ADDENDUM NO. 03

**Baggage Screening Improvements – Phase 2A**  
**[Loading Dock Reconfiguration, Sheriff’s Checkpoint Removal, Jetway Installation**  
**(Gate 30, 46, 47), IAB Airside Trash Remodel, North Checkpoint Relocation]**

PROJECT NO. A044-09002

DATE OF ADDENDUM: June 14, 2011

**E101A**

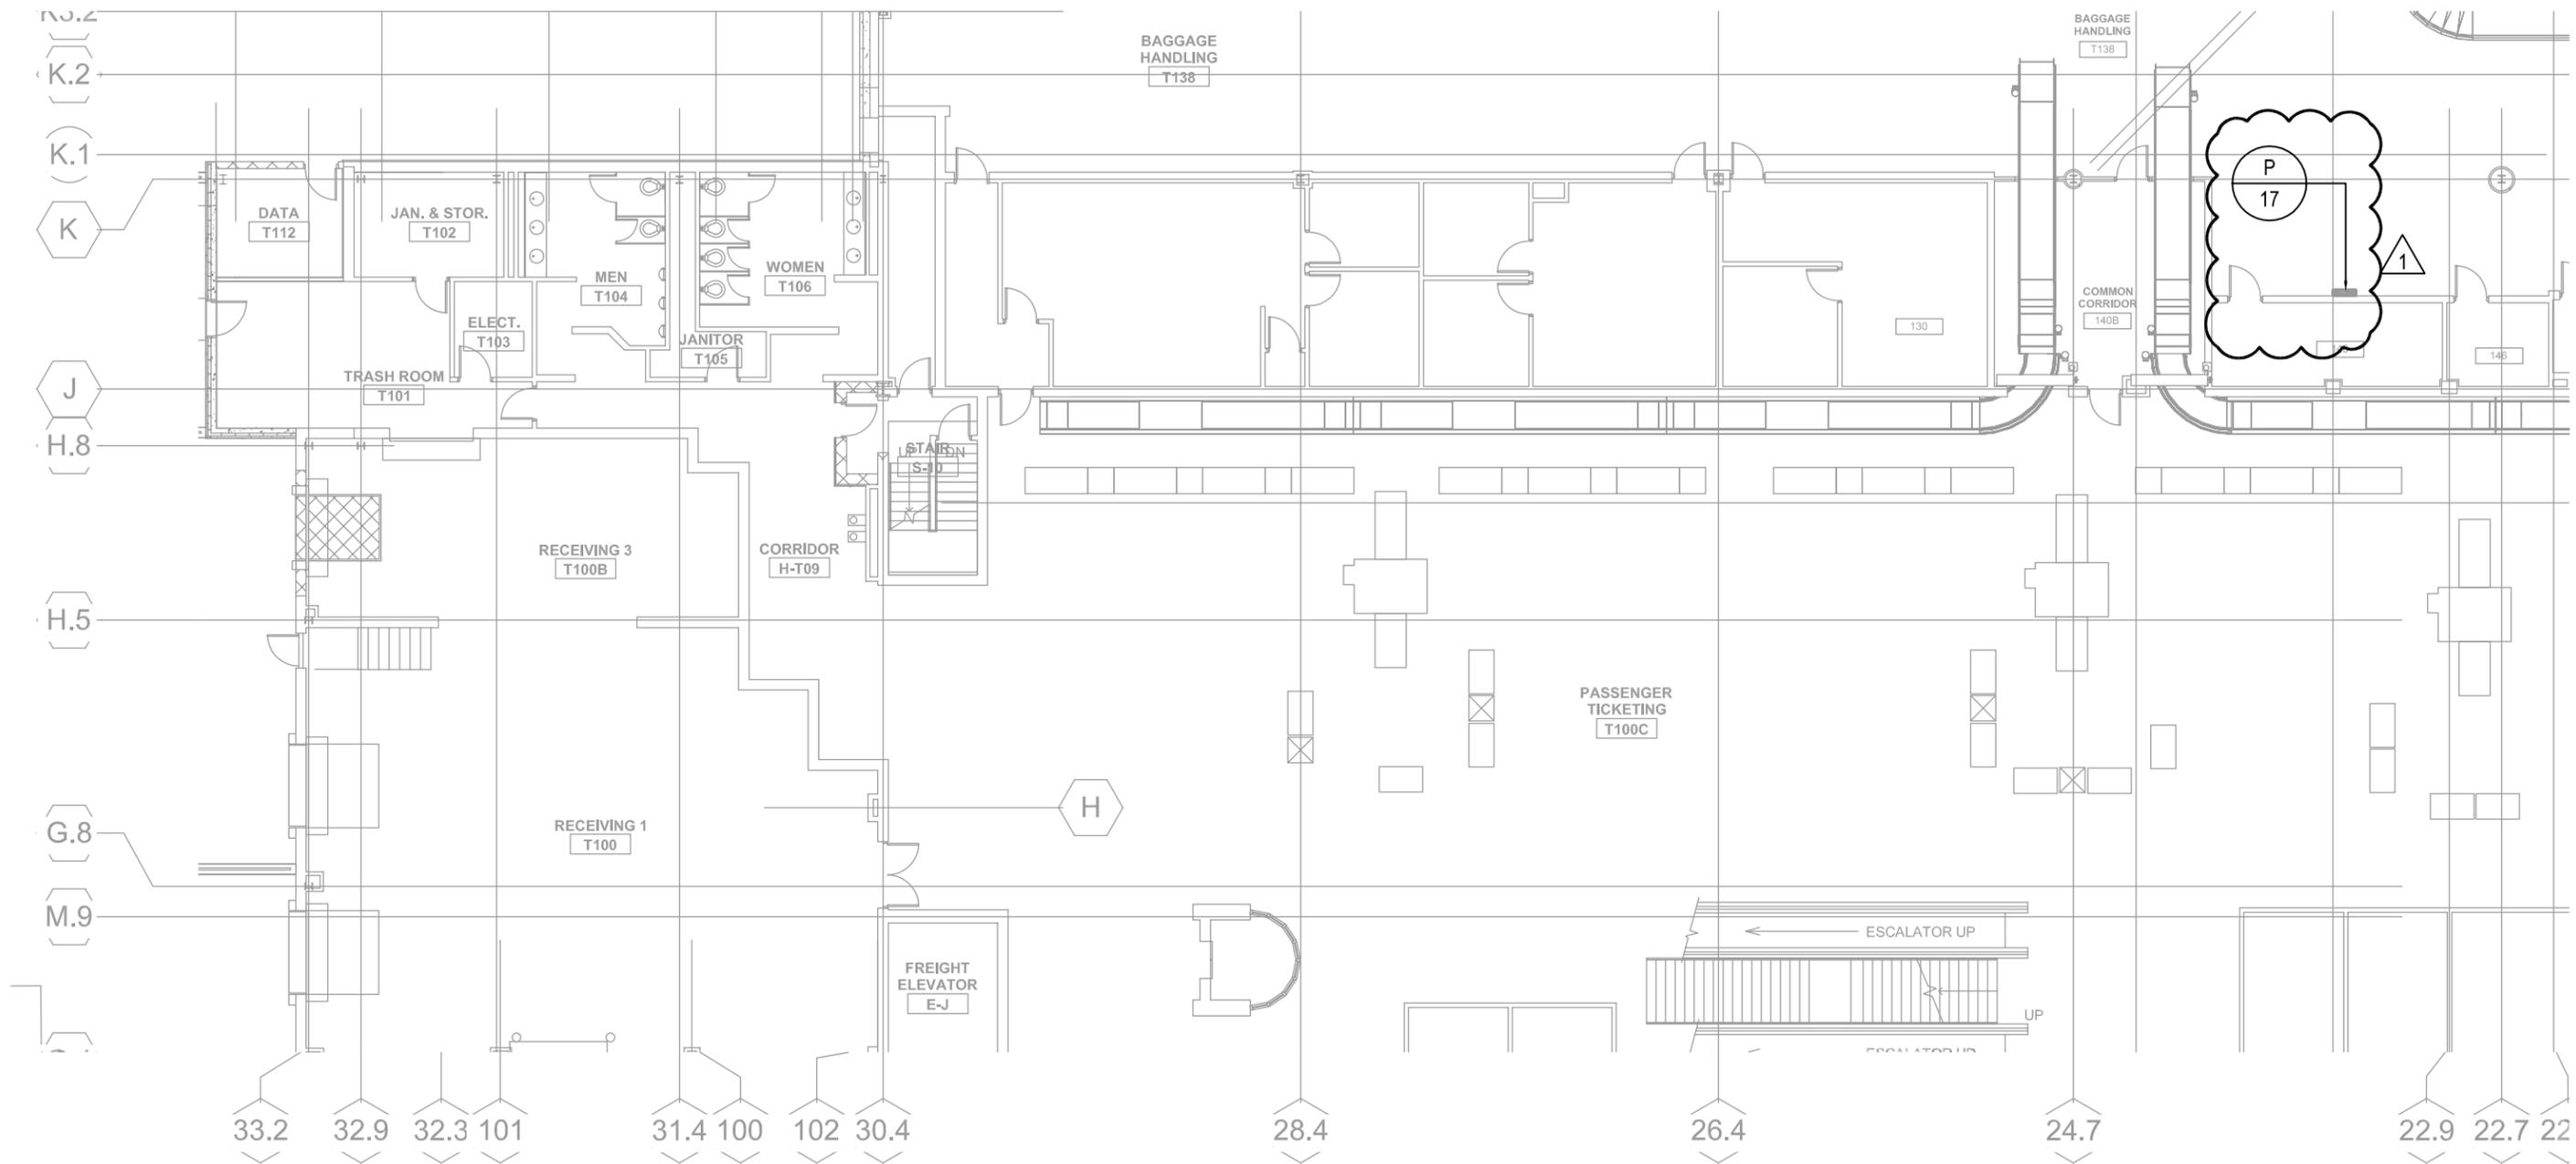
**E101A:** Changed drawing scale in plan view **2/E101A** for clarity. (refer to attached drawing)

# E104A

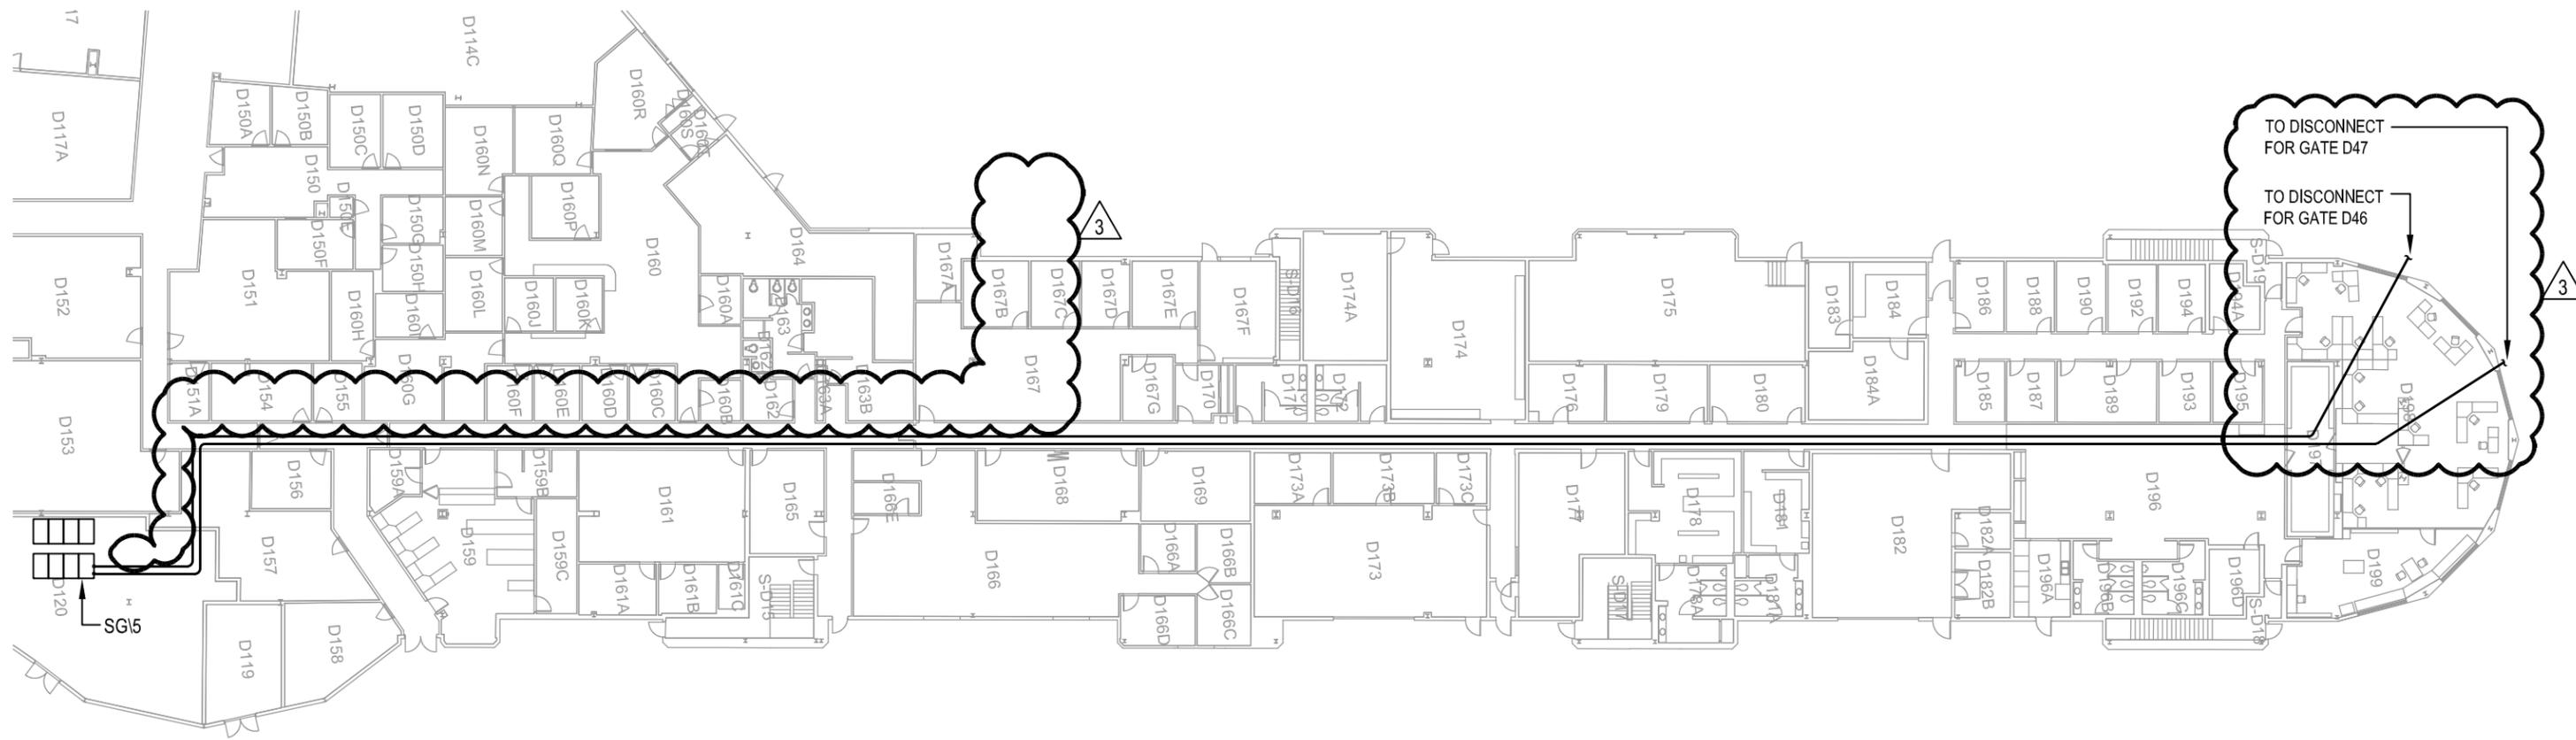
**E104A:** In Detail **1/E104A**, deleted feeder from S6/5 to Gate D30. Clarification for the location of the feeder to gates 46 and 47 (refer to attached drawing). Revise sheet note 9 as shown in attached drawing.

**E105A**

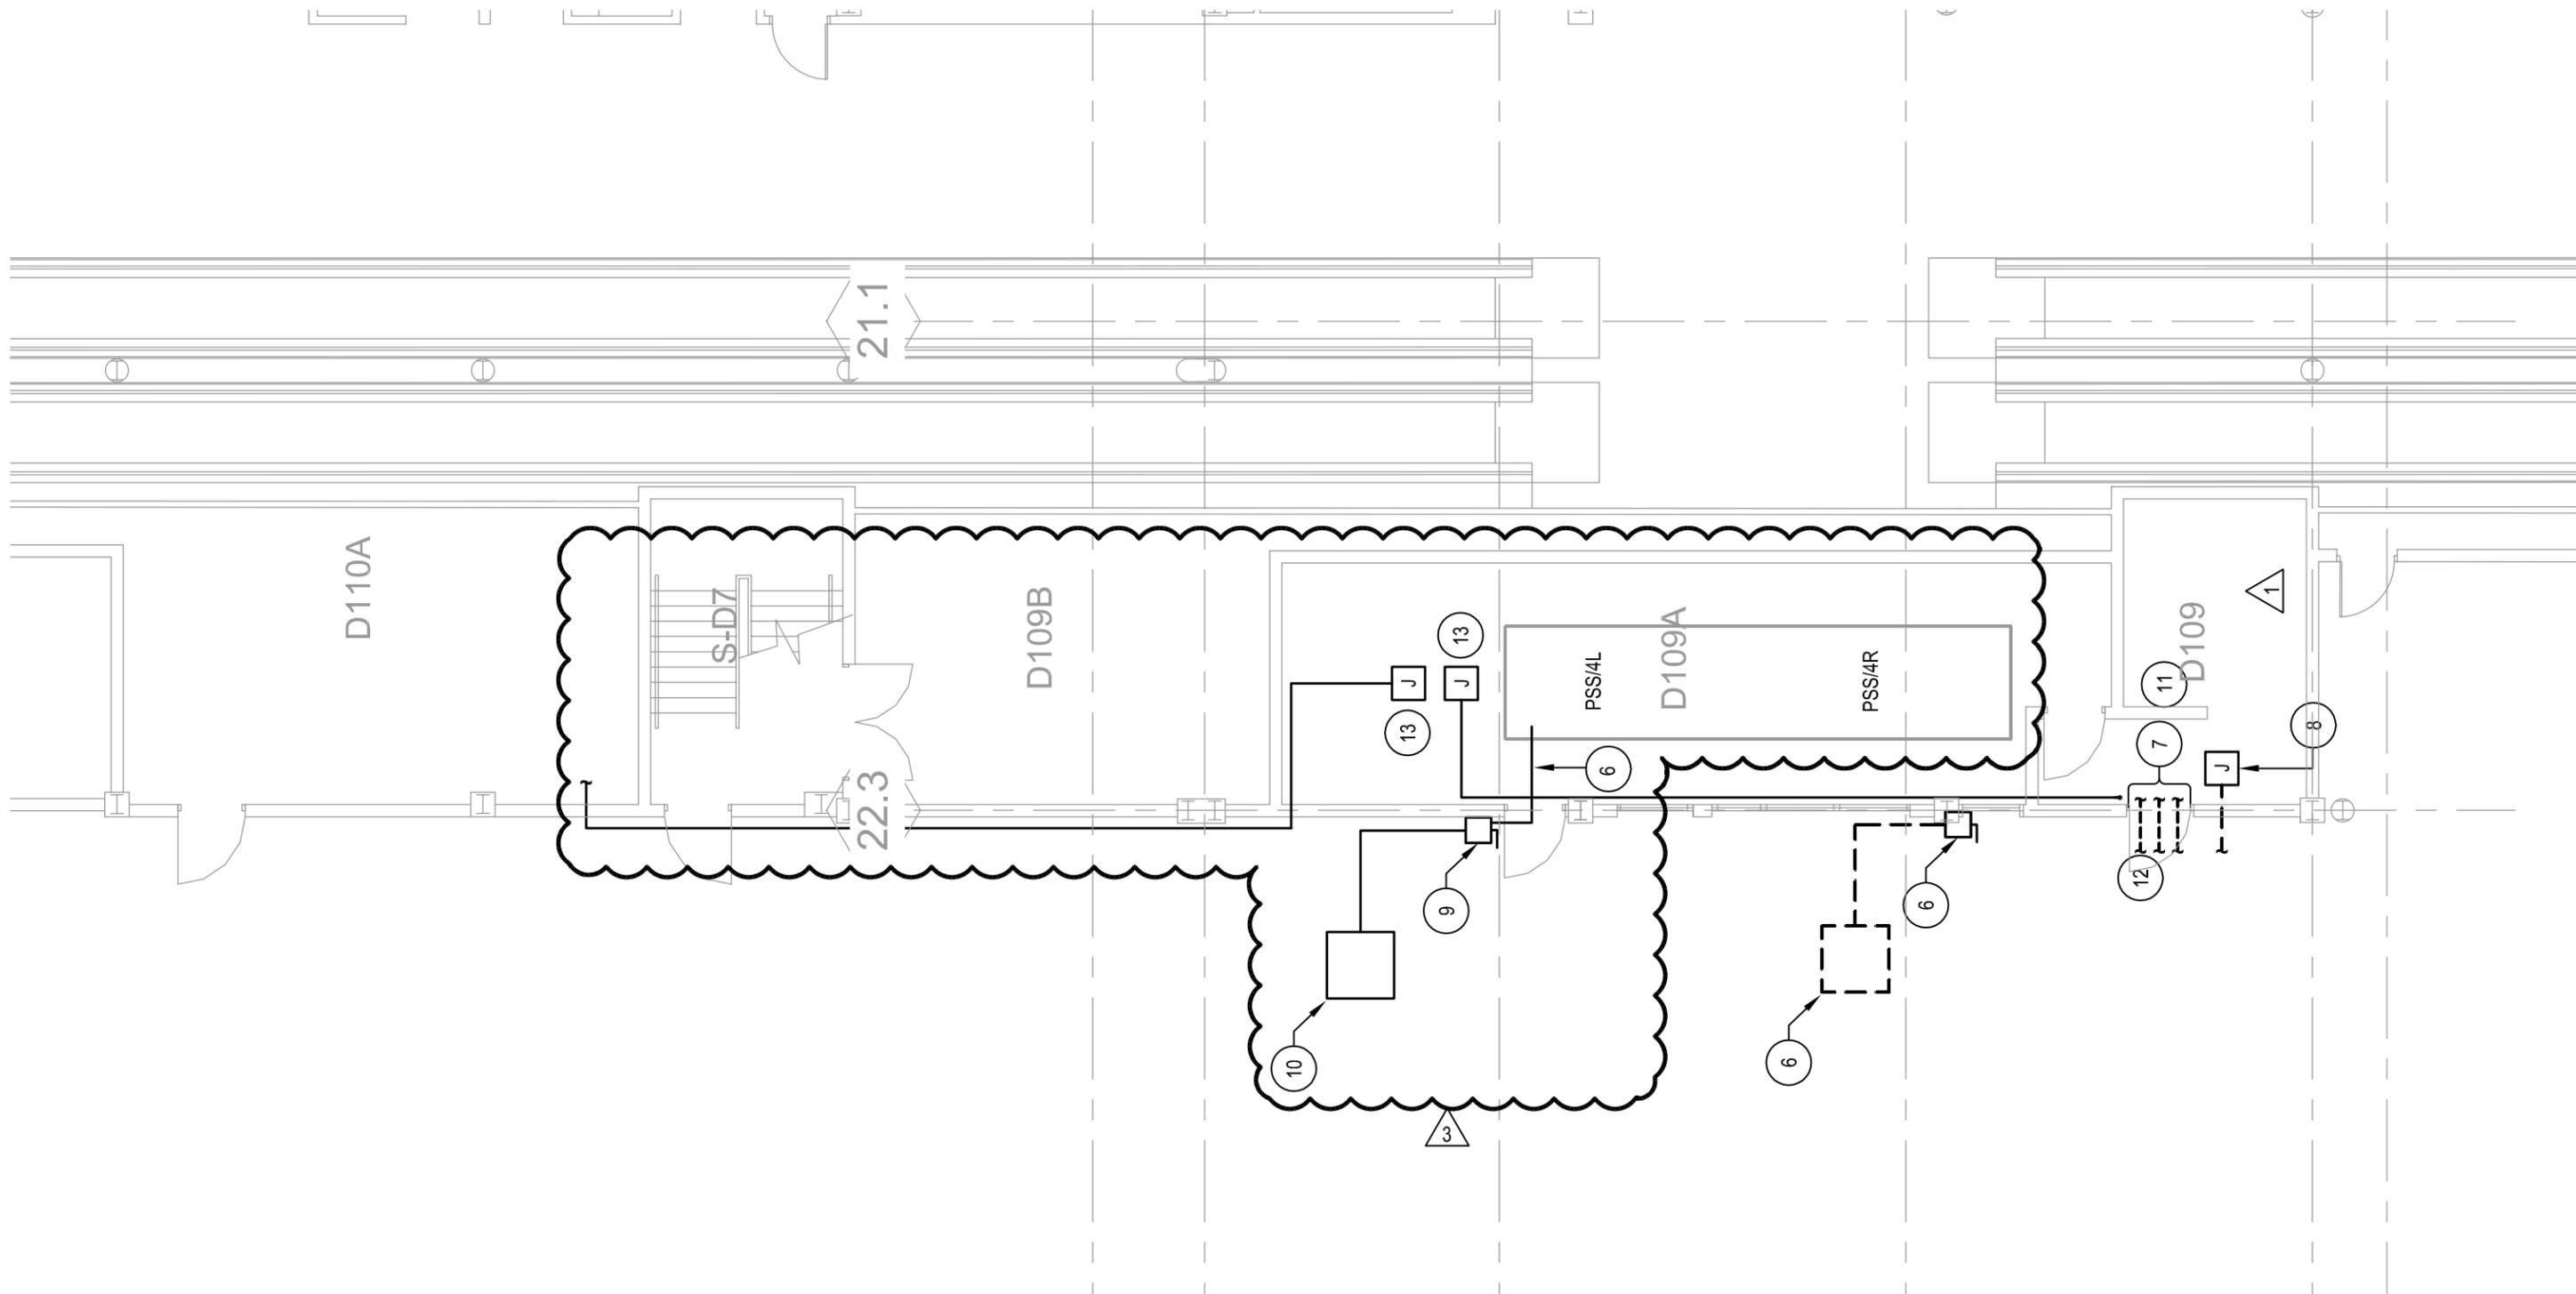
**E105A:** In detail **1/E105A**, added feeder from disconnect switch to PSS4/L (refer to attached drawing). Revised the route of the communications cable to room 110A (refer to attached drawing).

**E600A**

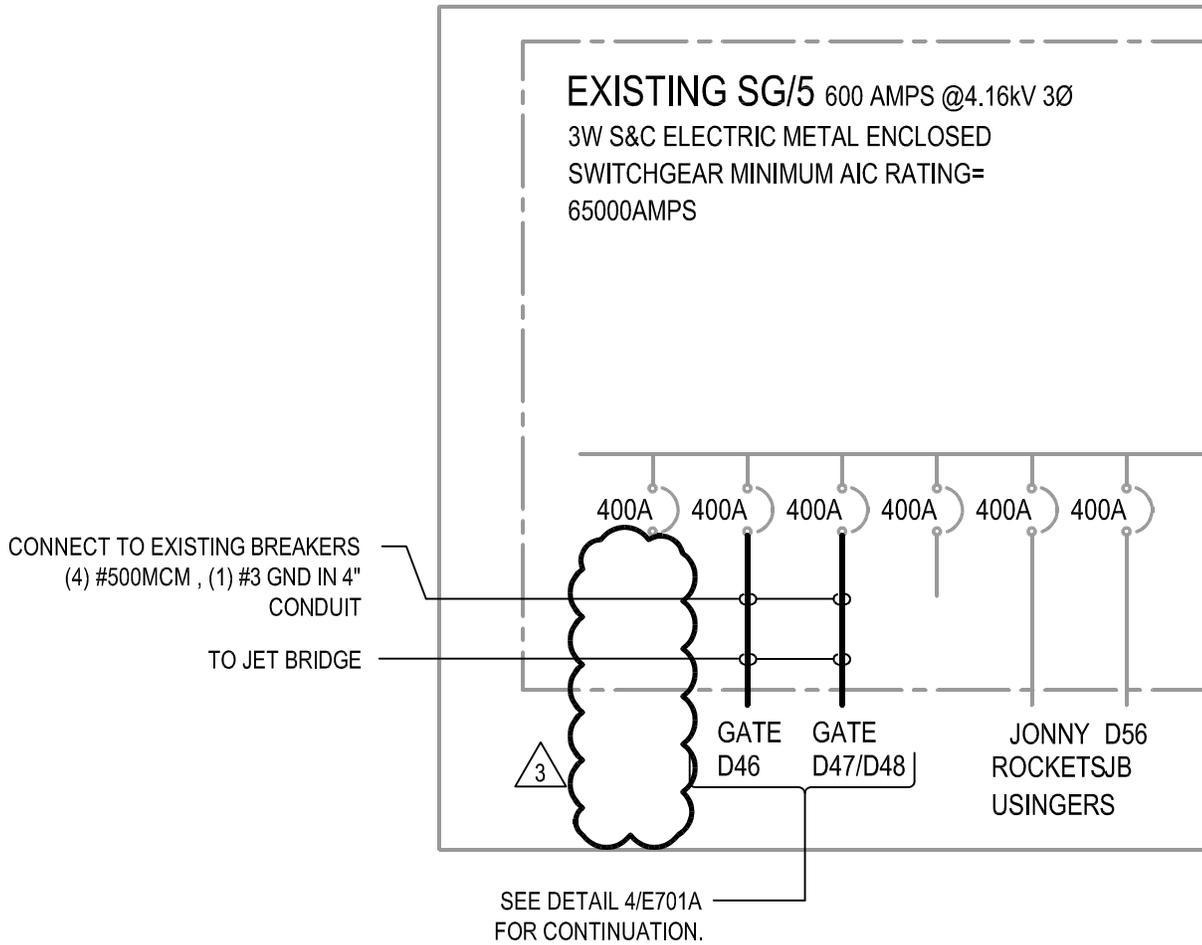
**E600A:** Revised one line diagram in detail **1/E600A** to reflect the change to the deletion of the feeder to gate D30 (refer to attached drawing).

**GATE D46 AND D47/D48 JET BRIDGE ELECTRICAL POWER ONE LINE DIAGRAM**

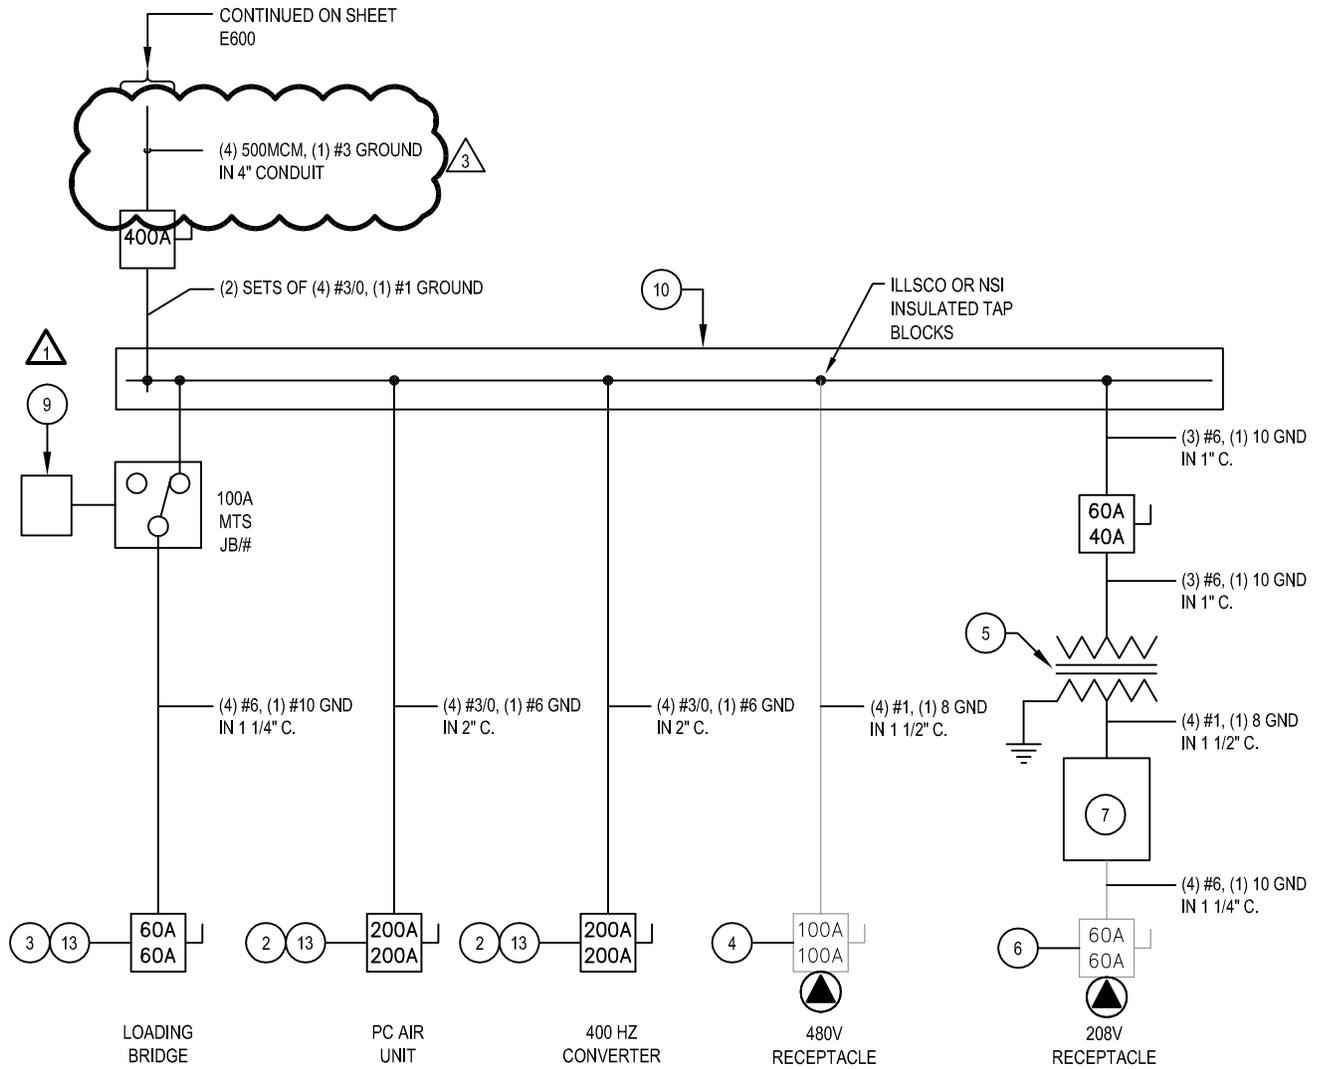
**E701A:** Revised the one line diagram **2/E701A** to show the new feeder for Gate D46 and 47 (refer to attached drawing).  
Adding a new one line diagram in detail **5/E701A** for the feeder to gate D30 (refer to attached drawing).
